SUBJECT: ISSUANCE OF AMENDMENTS (TAC NOS. 74100 AND 74101)

PACIFIC GAS AND ELECTRIC COMPANY  
DIABLO CANYON NUCLEAR POWER PLANT, UNIT 1  
DOCKET NO. 50-275  
AMENDMENT TO FACILITY OPERATING LICENSE

PACIFIC GAS AND ELECTRIC COMPANY  
DIABLO CANYON NUCLEAR POWER PLANT, UNIT 2  
DOCKET NO. 50-323  
AMENDMENT TO FACILITY OPERATING LICENSE

SAFETY EVALUATION BY THE OFFICE OF NUCLEAR REACTOR REGULATION  
RELATED TO AMENDMENT NO. 54 TO FACILITY OPERATING LICENSE NO. DPR-80  
AND AMENDMENT NO. 53 TO FACILITY OPERATING LICENSE NO. DPR-82  
PACIFIC GAS AND ELECTRIC COMPANY  
DIABLO CANYON NUCLEAR POWER PLANT, UNIT NOS. 1 AND 2  
DOCKET NO. 50-275 AND 50-323

FIGURE 3.4-2

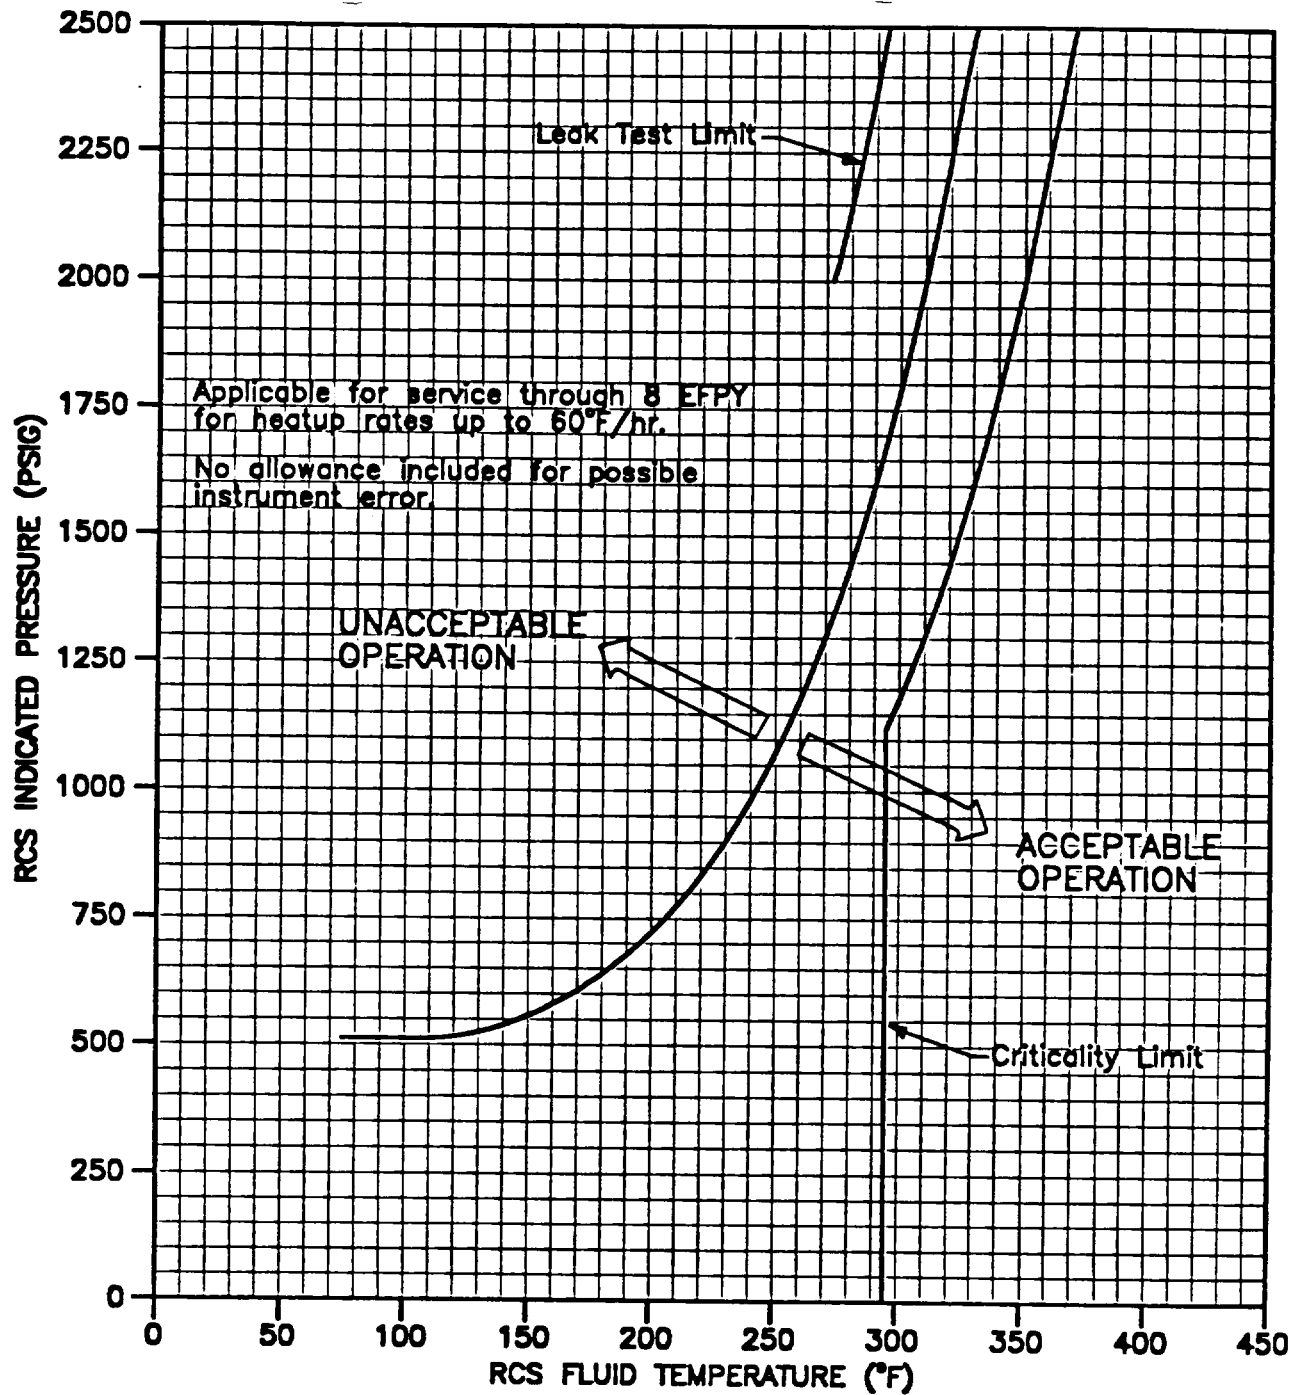
Item A     Figure 3.4-1, "Reactor Coolant System Heatup Limitations," and Figure 3.4-3, "Reactor Coolant System Cooldown Limitations," are revised to update the controlling chemical composition and P/T curves.

In reviewing these changes, the staff evaluated the effect of neutron irradiation embrittlement on each beltline material in the Diablo Canyon 1 and 2 reactor vessels. The amount of irradiation embrittlement was calculated in accordance with RG 1.99, Rev. 2. The staff has determined that the material with the highest ART at 8 EFPY for both units is intermediate shell plate B5454-2 in Unit 2. This plate is 0.14% copper (Cu) and 0.59% nickel (Ni), and has an initial  $RT_{ndt}$  of 67°F.

For the limiting beltline material, plate B5454-2, the staff calculated the ART to be 163°F at 1/4T (T = reactor vessel beltline thickness) and 142°F for 3/4T at 8 EFPY. The ART was determined using Section 1 of RG 1.99, Rev. 2.

The licensee used the method in RG 1.99, Rev. 2, to calculate an ART of 164°F at 8 EFPY at 1/4T for the same limiting plate material. The staff judges that a difference of 1°F between the licensee's ART of 164°F and the staff's ART of 163°F is acceptable. The licensee used a technique based on Section XI of the ASME Boiler and Pressure Vessel Code to calculate the Diablo Canyon 1 and 2 P/T limits. The staff has reviewed this technique and finds it acceptable, although it produces a P/T curve that is lower than the one the staff calculated using the methods of SRP 5.3.2. Thus, the staff verified that the proposed P/T limits for heatup, cooldown, and hydrotest meet the requirements of Appendix G of 10 CFR Part 50.

In summary, the NRC staff has concluded that the revised P/T limits for the Diablo Canyon Units 1 and 2 reactor coolant system for heatup, cooldown, leak test, and criticality are valid through 8 EFPY because the limits conform to the requirements of Appendices G and H of 10 CFR Part 50. The licensee's submittal also satisfies Generic Letter 88-11 because the licensee used the method in RG 1.99, Rev. 2 to calculate the ART. Consequently, the proposed P/T limits are hereby incorporated into the Diablo Canyon 1 and 2 Technical Specifications. Also, the staff finds the updated controlling chemical composition acceptable because it reflects measurements made on the limiting reactor vessel plate. Therefore, the TS changes identified under Item A, above, are acceptable.
